## QUALITY ASSURANCE -- NON-CONFORMANCE REPORT

**Report No:** NCR-000360

**Reference Description:** Base Metal Repair to Mis-Located Drill Holes

**Job Name:** SAS Superstructure

项目名称 Project Name:	美国海湾大桥 SFOBB	部件图号 Drawing No.:	FB20	报告编号 Report No.	B-CWR618
合同号 Contract No.:	04-0120F4	部件名称 Item Name:	Floor Beam	NDT报告编号 Report No. of NDT	NA
项目编号 Project No.:	ZP06-787

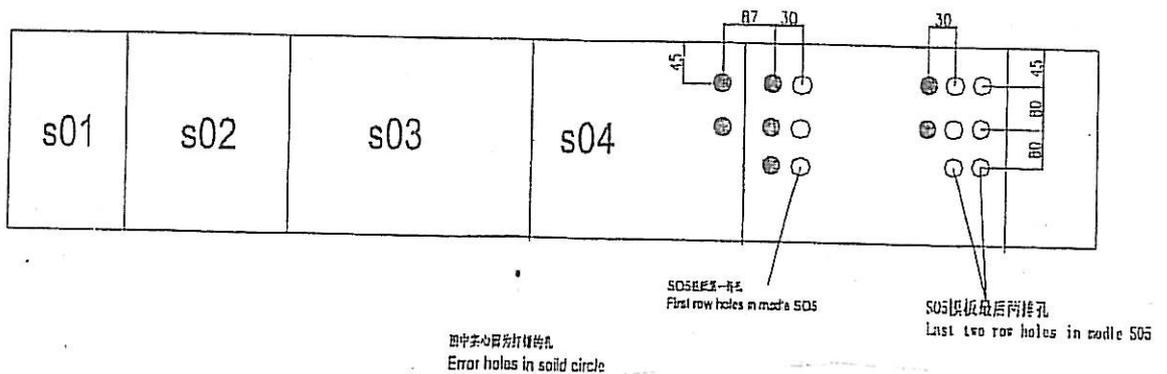
李政界施工队在对FL3横隔板钻孔时,因未看清图纸要求,导致翼缘板错误钻孔7个。图号为FB020-005,施工队在没有返修报告情况下已安排堆焊,具体位置见图:

FL3 Floor beam fabricated by Li Zhenjie Work Team, it didn't review drawing requirement caused seven holes drilled error, drawing No.: FB020-005, and Work Team repair holes without approved CWR, the detail position sees the following draft.

- 6. 按照批准的WPS预热和焊接;
  - 7. 打磨返修区域与母材和临近焊缝平齐;
  - 8. 按照WPS程序进行VT,MT,UT检测;
  - 9. 对承受拉应力和反向应力的构件焊缝修补区域应按照AWS D1.5, 3.2.2.3上要求的UT和MT进行检测;
- 1. The Engineer shall be notified and present during this repair.

- 2. QC and a Lead CWI shall be present and direct all gouging, grinding and welding operations during this repair.
  - 3. QC and a Lead CWI shall have an approved copy of the CWR in hand prior to the repair.

- 4. QC and a Lead CWI shall direct the repair to ensure the repair is per the disposition requirements.
  - 5. Prepare the excavation according to the approved WPS details.

- 6. Perform preheating and welding in accordance with the approved WPS.
  - 7. Grind the repaired area flush to base metal or the adjacent weld.
  - 8. Perform VT, MT and UT inspections according to the approved WPS procedure.

- 9. Weld repairs are being performed on TM/SRM member per AWS D1.5, 3.2.2.3 UT and MT is required.

项目名称 Project Name:	美国海湾大桥 SFOBB	部件图号 Drawing No.:	FB20	报告编号 Report No.:	B-CWR636
合同号 Contract No.:	04-0120F4	部件名称 Item Name:	OBG FLOOR BEAM	NDT 报告编号 NDT Report No.:	B787-UT-7838
项目编号 Project No.:	ZP06-787

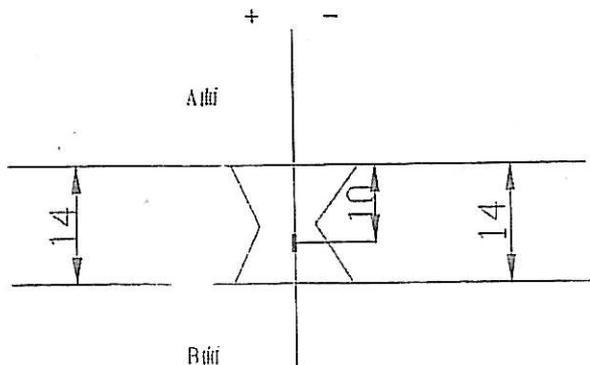
Two defect found by use of UT on the build-up No. X73E

( ITEM X73E的堆焊处发现3处缺陷) Welder ID No.062645 Position:1G

1. 火焰加热时, 水汽没有完全的去掉或者这个区域预热不够;
1. Moisture wasn't completely removed during drying operation (preheating) or the area wasn't preheated sufficiently.

1. QA and CWI should be present to witness the repair.
  2. Elongate the hole by arc gouging, and grind smooth the surface. The elongated hole should conform to the joint detail in Repair WPS. Preheat before gouging according to relevant WPS.
  3. Perform VT and MT to ensure no defects exist.
  4. Add steel backing. Preheat and weld according to the repair WPS, weld stringers longitudinally along the elongated direction of the hole.
  5. Remove steel backing and back gouge the root pass, MT backing area prior to welding and complete the welding. *BACK GOUGER* *8-3-09*  
*IN ACCORDANCE W/ APPROVED WPS.*
  6. Grind the repair area flush with adjacent base metal.
  7. Cooling time shall conform to AWS D1.5 section 12.16.4 approved FCP.
  8. Check with VT, UT, MT after welding to the repair area.
- Note: ALL gouging, grinding and welding should be inspected by QC and Leader CWI.

1. QC shall verify sufficient preheat has been applied, to remove moisture, prior to welding.
